MONTGOMERY COUNTY HISTORIC PRESERVATION COMMISSION
STAFF REPORT

Address:	23 Primrose St., Chevy Chase	Meeting Date:	7/11/18
Resource:	Contributing Resource Chevy Chase Village Historic District	Report Date:	7/5/18
Applicant:	Elizabeth McGrann	Public Notice:	6/27/18
Review:	HAWP	Tax Credit:	N/A
Case Number:	35/13-18R	Staff:	Dan Bruechert
Proposal:	Window well and bay window construction, fence alteration.

RENOVATION TO THE
McGRANN
RESIDENCE
23 PRIMROSE STREET
CHEVY CHASE, MD 20815
LOT: P16 BLOCK: 58

2
A003
PROPOSED PORTICO ELEVATION
 SCALE: 3/4" = 1'-0"
 ■ NEW CONSTRUCTION

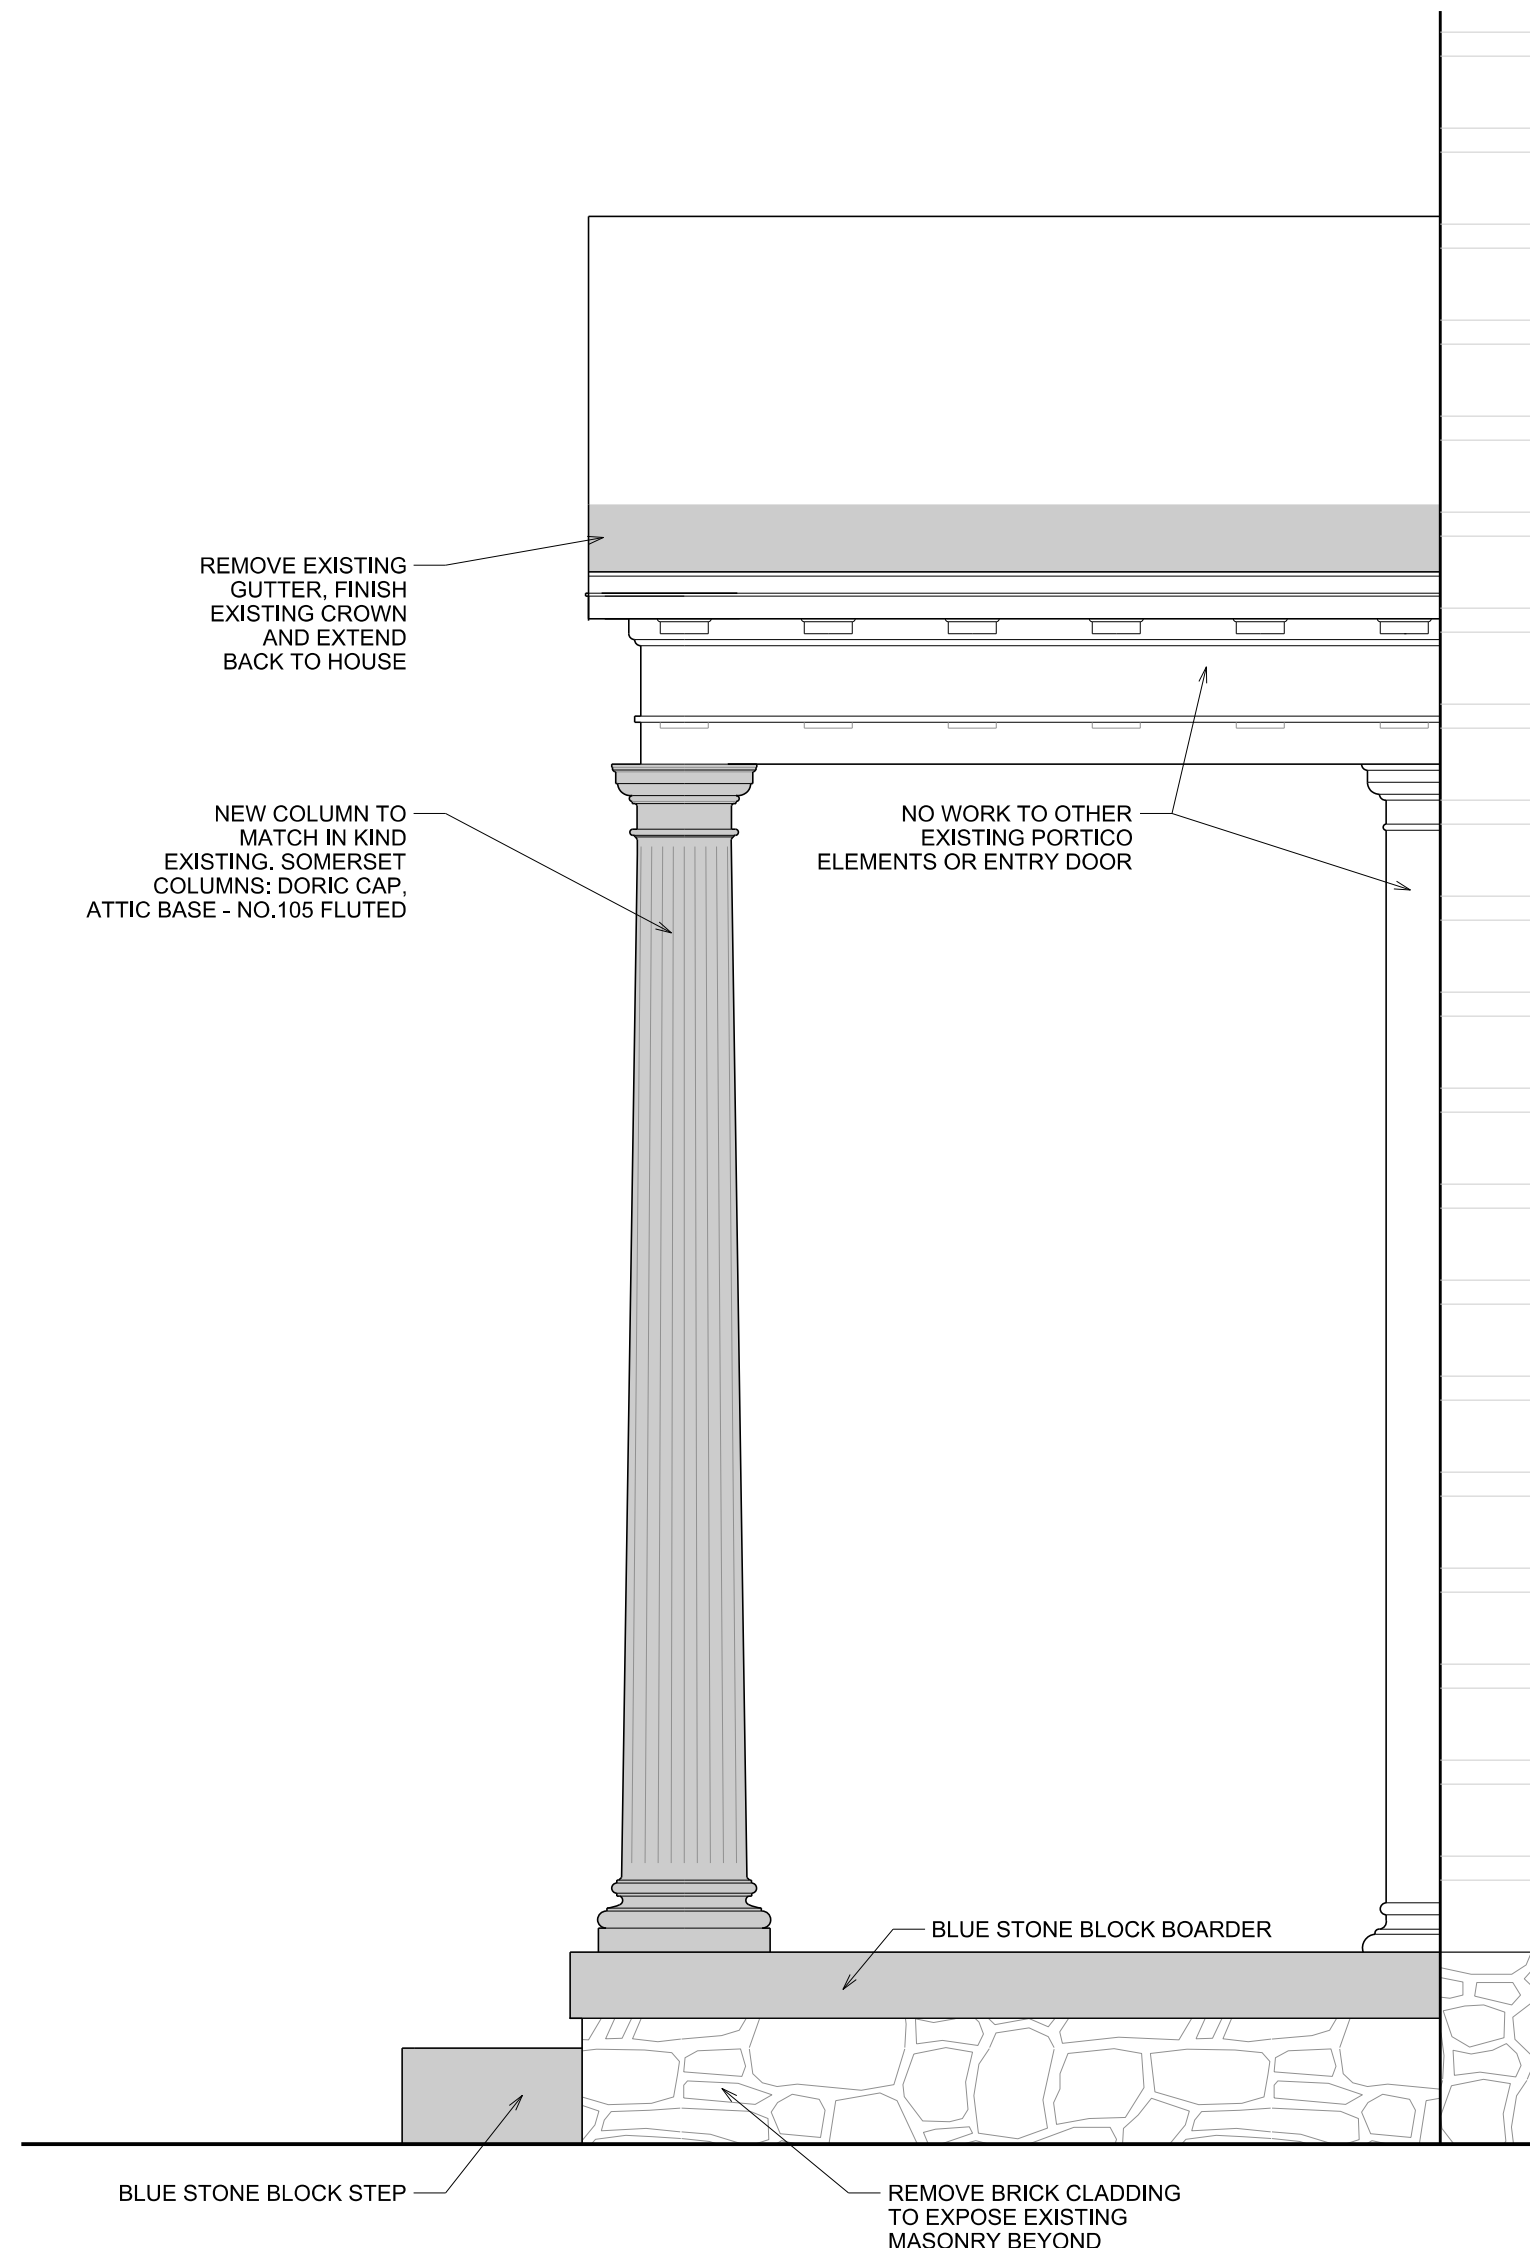
The applicant proposes to re-clad the front porch and step in bluestone and construct a new bluestone block landing. While this is not a masonry material that would have been used at the building's construction date, it is a solid masonry material which is appropriate for the front porch and is compatible with the surrounding district and Staff supports its approval. The porch is an altered feature that has lost some of its historic integrity. The change in material is appropriate under Standard 9 while maintaining the historic character per Standard 2.

3 EXISTING EAST ELEVATION
 A004 SCALE: 1/4" = 1'-0"

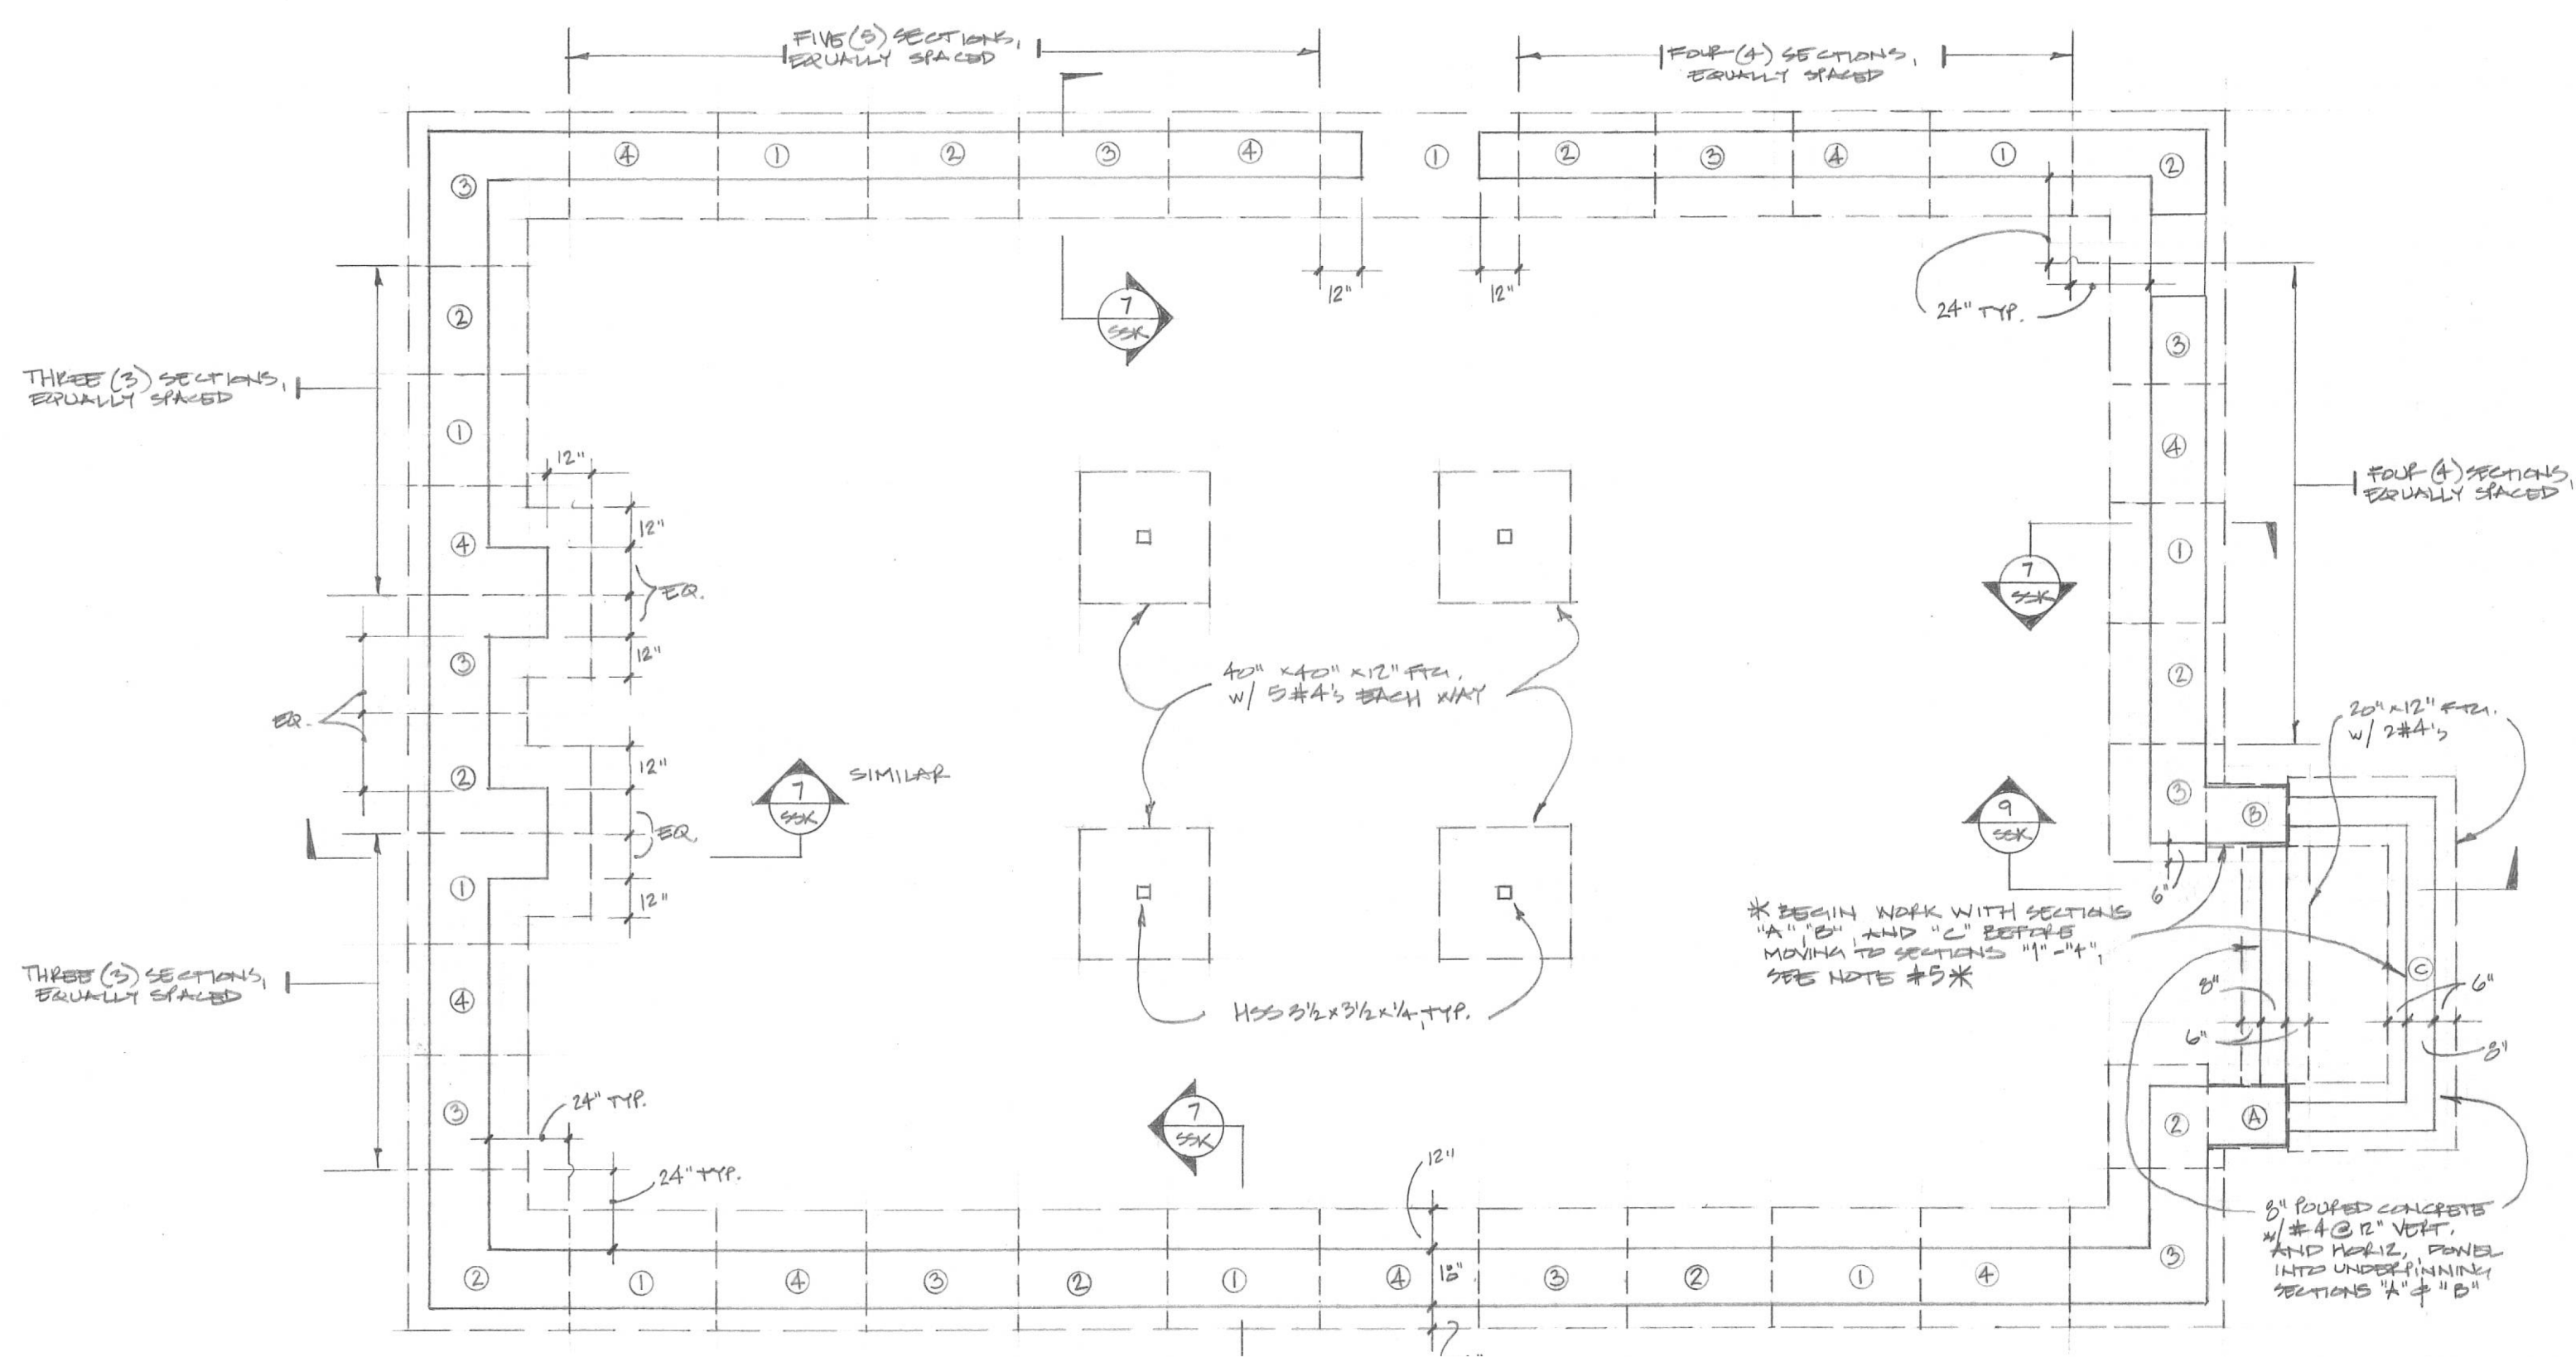
Currently, on the east elevation, under the bay window there are three narrow, fixed windows. The applicant proposes replacing these windows, covering the existing opening with a piece of flat trim board, and constructing a 4' × 7' (four feet by seven feet) window well in its place. The only portion of the proposed window well that will be visible is the bluestone cap surrounding it. There will be a metal grate covering the window well that will be flush with the cap. The

window well wall will be concrete. The applicant proposes installing a pair of double-hung six-over-one wood sash windows to provide egress from the basement. Window wells do not fit neatly into any of the categories identified in the *Design Guidelines*, however, the installation of this feature will have a minimal impact on the house when viewed from public right-of-way and to the surrounding district. Additionally, the materials of the cap and windows are appropriate for the character of the house and surrounding district. This is not a substantial alteration of the features of the house and meets the requirement of 24A-8(b)(1). Staff supports approval of the proposed window well.
